# Product Change Notification

Date Issued :	February 23, 2024	PCN Number :	514899
Reason for Change :	Packaging Method/Quantity Changing		
Description of Change :	This notification is to inform you about part(s) listed will undergo changes for packaging method change. No changes will be made to product as part of this change.		
Reason for Short Notice :	Special Request		
Assessment of Change :	Drop Test		
Planned Implementation Date :	March 08, 2024		
Customer Sample Availability Date:	February 20, 2024		
Last date to request Samples by Customer :	February 29, 2024

## Before – RAST 5 Series- 90879 and 93003 (2-7 Circuit)

## After – RAST 5 Series - 90879 and 93003 (2-7 Circuit)

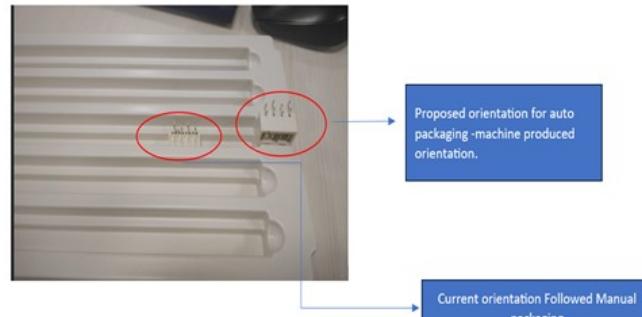
- **Packaging Method change:** Orientation change of FG parts in current tray packaging to facilitate auto packaging. To align same orientation of the machine output to the trays .
- Non-Du change. Other packaging material and packaging method remains the same.
- **Product Impact:** There is No impact to Fit, Form & Function of the product
